# Access Compliance Report

## Public Rights-of-Way

### (Curb Ramps)

Intersection ID: 47584	Main Street: GLENBURN_LN	Cross Street: EVANTON_LOCH_RD	Location: NW
ADA ID: 814C3ABA19C9	Ramp Type: PerpDiag	Initial Pass/Fail: Fail	Overall Compliance: No
Severity Score: 8.75			
Codes/Mitigation Info/Possible Solution		Field Measurements/Component Compliance

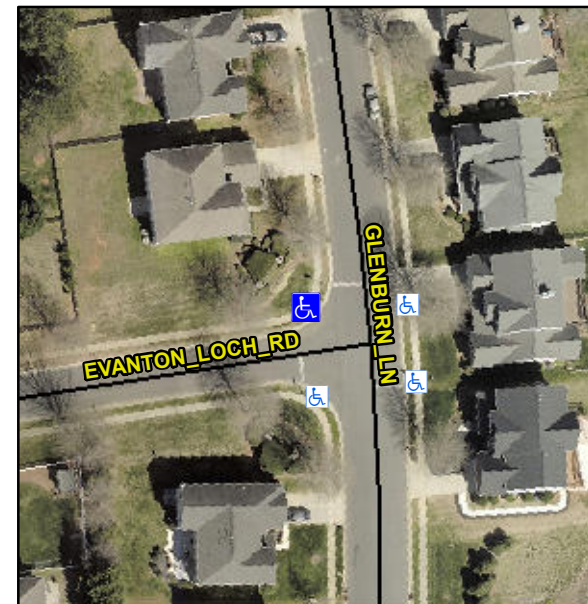
**Not Found, R304.5.1**

Compliance	Description	Data	Compliance	Description	Data
N/A	Ramp Length (in)	46.0	Yes	Ramp Slope (%)	5.6
No	Ramp Width (in)	45.5	Yes	Ramp XSlope (%)	0.7
N/A	Flare Type LT	N/A	N/A	Flare Type RT	N/A
N/A	Flare Slope LT (%)	N/A	N/A	Flare Slope RT (%)	N/A
N/A	Flare Traversable LT?	N/A	N/A	Flare Traversable RT?	N/A
N/A	Landing Length (in)	N/A	N/A	DWS Provided?	N/A
N/A	Landing Width (in)	N/A	N/A	DWS Contrast?	N/A
N/A	Landing Slope (%)	N/A	N/A	DWS Length (in)	N/A
N/A	Landing X Slope (%)	N/A	N/A	DWS Full Width?	N/A
N/A	Landing Curb? (Y/N)	N/A	N/A	DWS Offset (in)	N/A
N/A	Shared Landing?	N/A			
N/A	Gutter Ponding?	N/A	N/A	Gutter Slope (%)	N/A
N/A	Gutter Lip Ht (in)	N/A	N/A	Gutter X Slope (%)	N/A
N/A	Painted X Walk1?	No	N/A	Painted X Walk2?	No
	X Walk 1 Direction	To S		X Walk 2 Direction	To E
N/A	X Walk 1 Width (in)	N/A	N/A	X Walk 2 Width (in)	N/A
	X Walk 1 Slope (%)	1.6		X Walk 2 Slope (%)	1.3
	X Walk 1 X Slope (%)	0.3		X Walk 2 X Slope (%)	1.9

**Remove & Replace Curb Ramp With Two New Directional Ramps or Equivalent.**
